Docket Item # 6
BAR CASE # 2008-0193

BAR Meeting
May 6, 2009

ISSUE: New Construction
APPLICANT: Sophie Development LLC
LOCATION: 714 Wythe Street
ZONE: OC/Office Commercial

Figure 6. Current submission, side elevation.

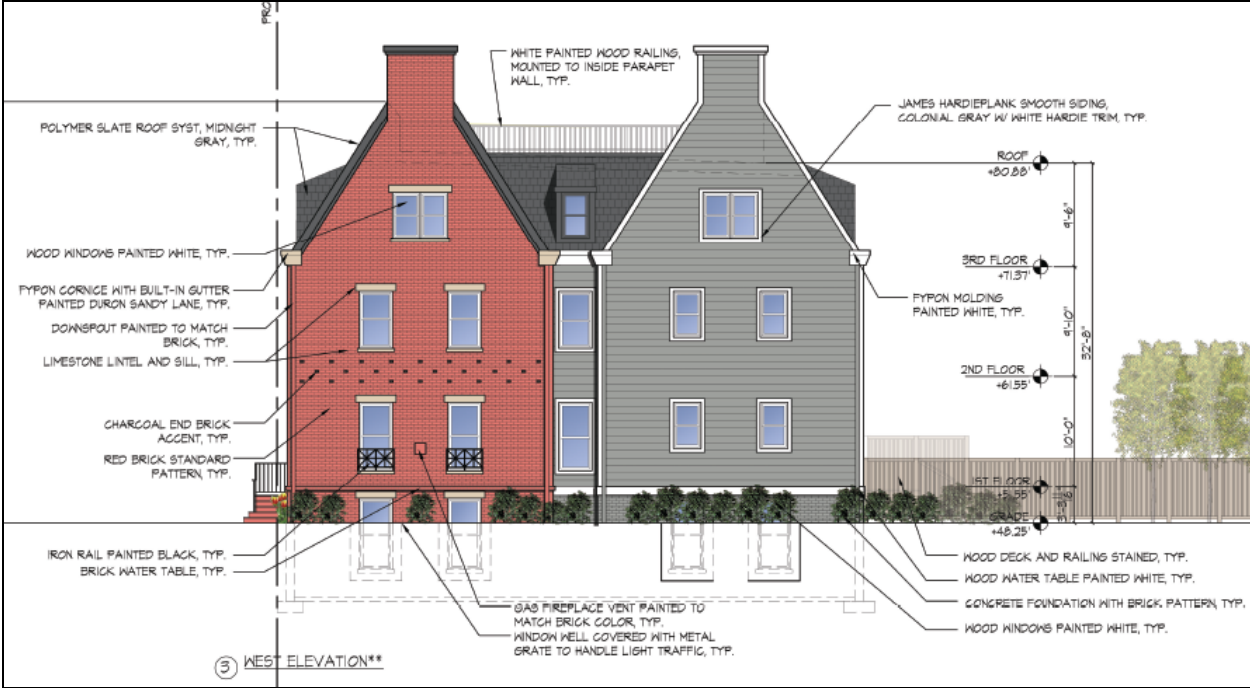
the district. Further, the use of the gable form at the rear addresses earlier concerns regarding the height and mass of the rear portion. Staff finds the treatment appropriate but finds that the hyphen connecting the two gable elements should be slightly revised. The size of the proposed windows in the hyphen appears disproportionate against the wall plane of the hyphen. Staff recommends reducing the size of the windows or selecting a different window type which would allow the hyphen to read as a distinct element of the design.

In summary, Staff is supportive of the current scheme with a revision of the window size on the hyphen to make it more proportional to the wall plane.

1. That the first- and second-story windows on the hyphen be reduced in size to more proportionally fit the space.
2. *The applicant/developer shall call Alexandria Archaeology immediately (703-838-4399) if any buried structural remains (wall foundations, wells, privies, cisterns, etc.) or concentrations of artifacts are discovered during development. Work must cease in the area of the discovery until a City archaeologist comes to the site and records the finds.
